Local Planning Panel

Agenda

Item 3.**Development Application: 1-3 Goddard Street, Erskineville - D/2019/880**

File No.: D/2019/880

Figure 21: Extract from section drawing showing level 3 being setback from the building line to ensure it is not visible from Goddard Street. The dashed red line provides sightlines from Goddard Street.

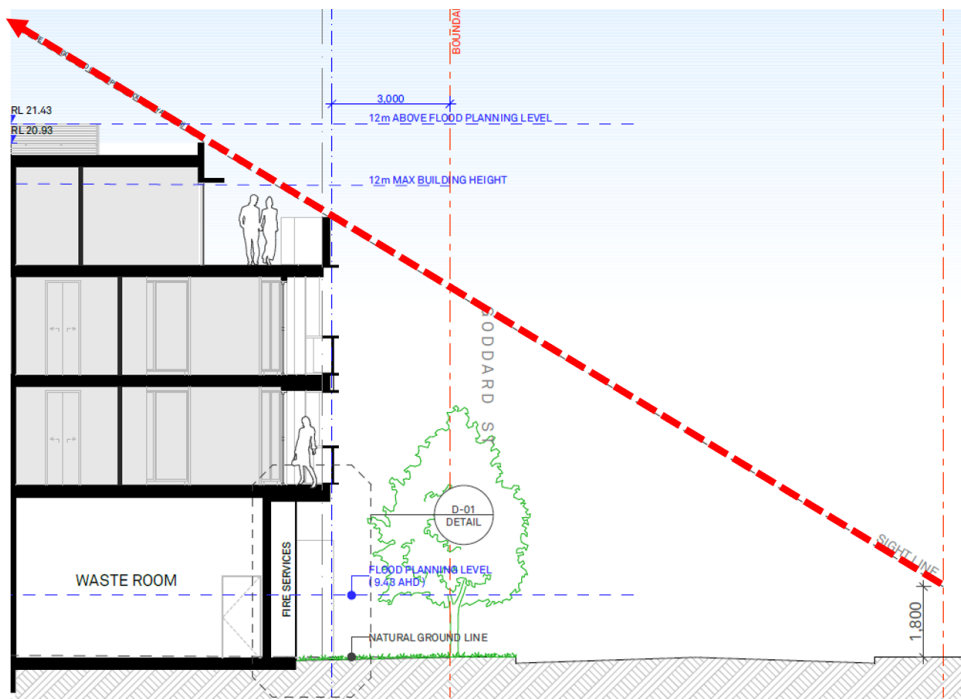
41. The 3 storey form at the Goddard Street boundary is consistent with the height in storeys control for the lower level of 5 Goddard Street, which is the neighbouring site to the south. Figure 23 below sets out that future development within 5 Goddard Street must also be constructed as a 3 storey development as viewed from Goddard Street, with a 6 storey form able to be approved for the western portion of that site.

42. The proposed 4 storey height for the remainder of the subject development provides a suitable height transition between existing 3 storey terrace dwellings to the north of the site (1A-1F Goddard Street) and potential 6 storey development within 5 Goddard Street.

Figure 28: Section plan, showing the proposed building height exceeding the 12m SLEP2012 control (dashed red line added for emphasis). The proposed maximum building height is 12m above the required floor levels as per flood engineer's advice.

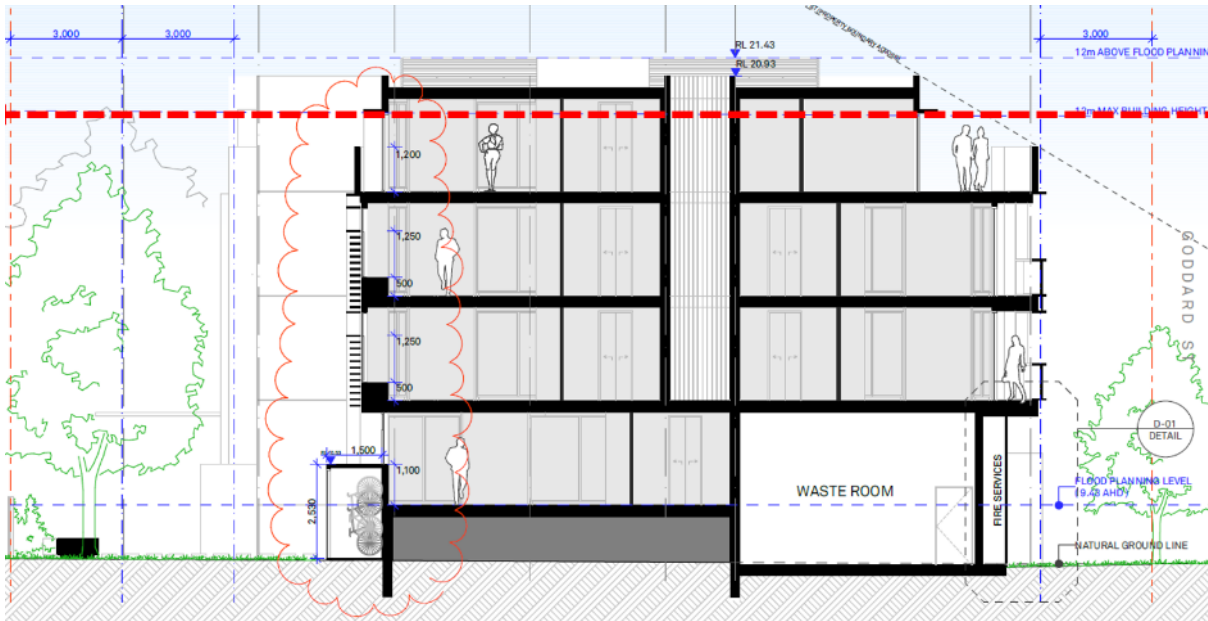
47. The site is subject to a maximum building height control of 12m. The proposed development has a maximum height of 13.56m and exceeds the control by 1.56m (13%) - see Figure 28 below. The proposed development has a height of 4 storeys and exceeds the maximum 3 storey height control as shown in the relevant SDCP2012 Ashmore Height in Storeys map.

Figure 32: George Street elevation with dotted red line indicating approximate street frontage height

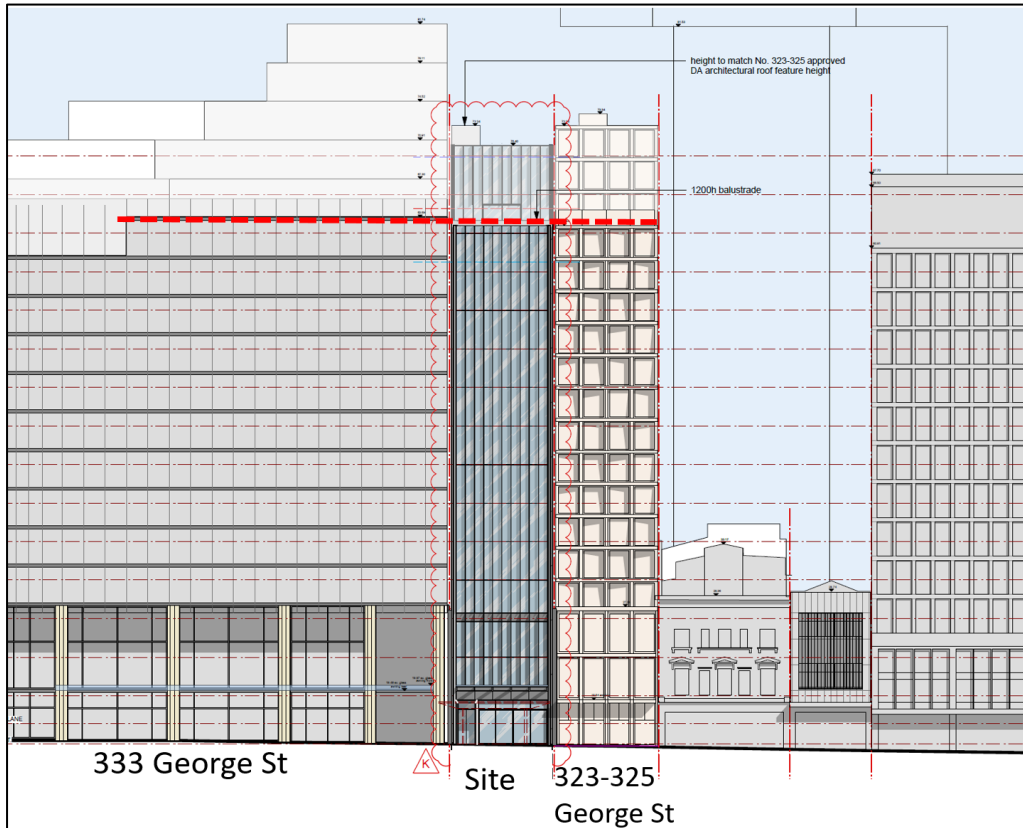
- 40. The proposed street frontage height, front and rear setbacks of the building do however respond to that of the existing adjoining building to the south at 331-339 George Street and to the recently approved development on the adjoining site to the north at 323-325 George Street.
- 41. The images provided in Figures 32 to 35 below depict the proposed building's relationship to the street frontage height and setbacks of the adjoining buildings.

Figure 37: Proposed ground floor plan

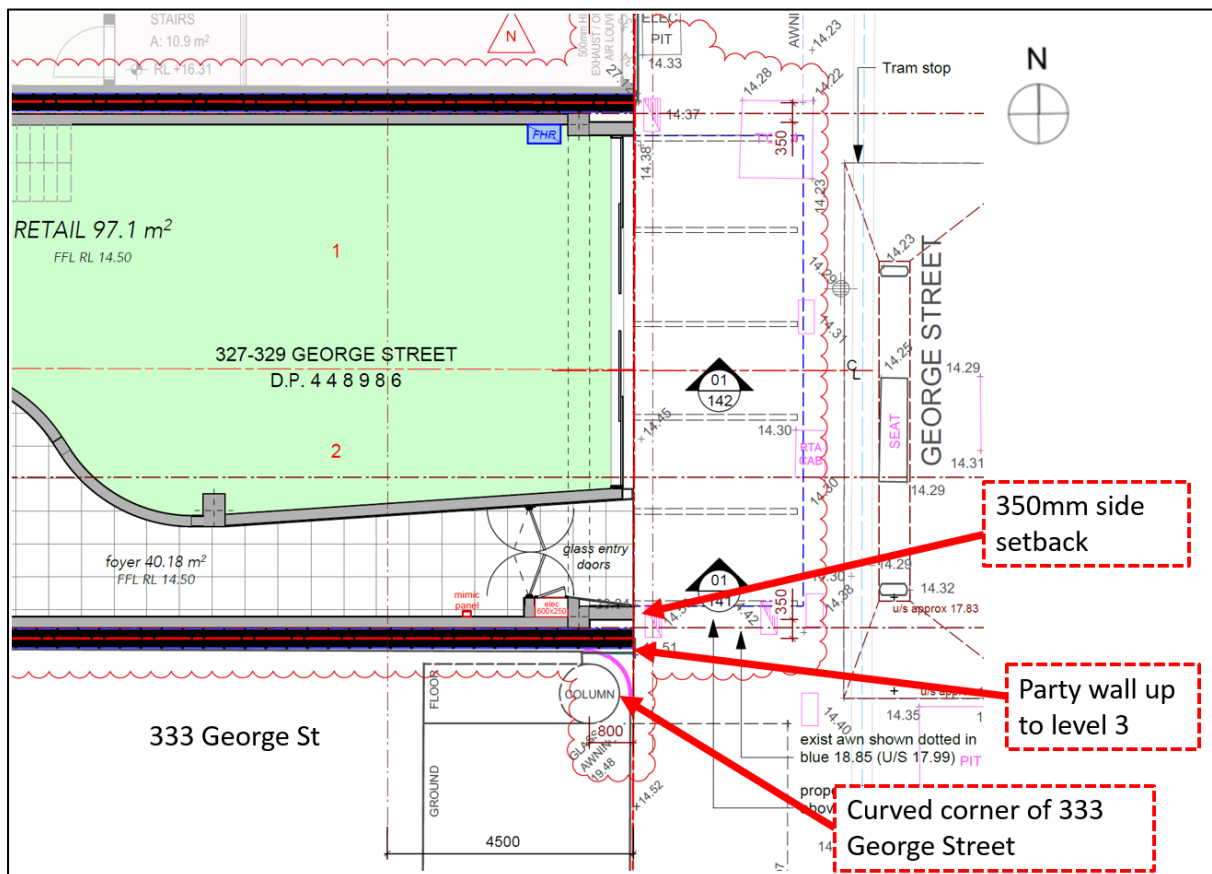
55. The originally submitted proposal had a blade wall along the full length of the southern boundary up to level 12, which obscured the rounded corner of 333 George Street. This issue was raised as a concern during the preliminary assessment.
56. In response to this issue, the applicant amended the proposal by providing a 350 millimetre side setback at the George Street frontage for a depth of 800 millimetres (as measured from the front boundary).
57. This is to allow the curved corner of 333 George Street to remain partially exposed and legible. While this is supported, the drawings indicate that the existing party wall protrudes to the front property boundary, as shown in the image depicted in Figure 37 below.

58. As seen above, the extent of the party wall (as drawn on the plans) defeats the purpose of providing a 350 millimetre setback in order to see the curved corner.
59. A site inspection revealed however that the existing party wall, or the part of the party wall located at 331-339 George Street, is setback from George Street alignment, as shown in the images depicted in Figures 38 and 39 below.

Figure 40: Long section (west - east) of upper levels showing portions of the building above 55 metres (dashed blue line)

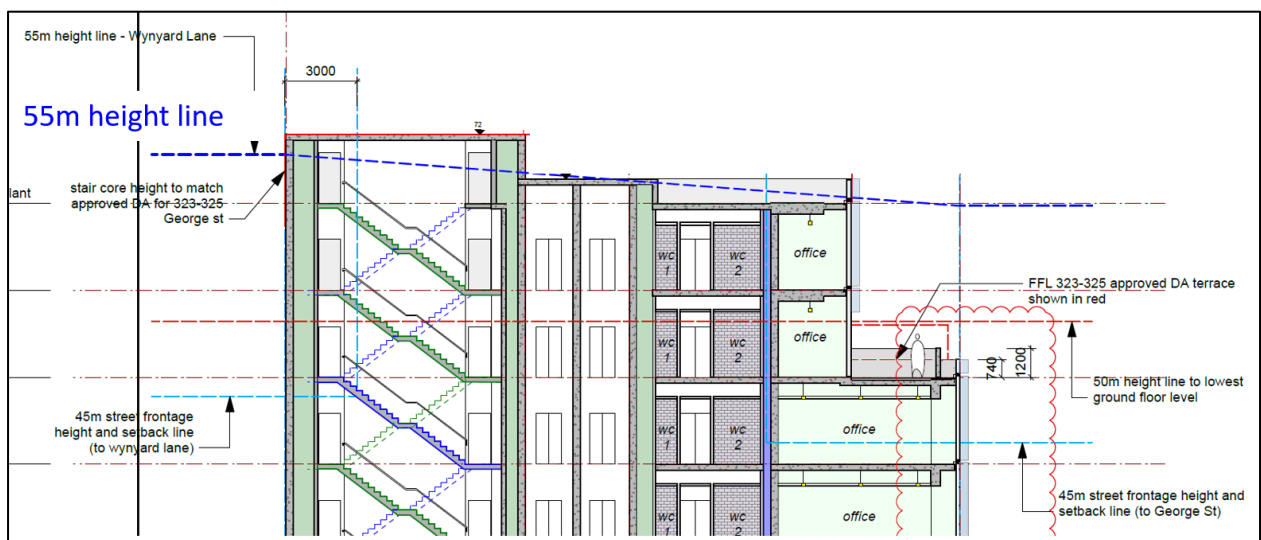
69. The part of the building which is located above 55 metres is limited to the fire stairs and parapet as shown in Figure 40 below. As depicted, the extent of the exceedance is very minor and does not comprise any gross floor area.
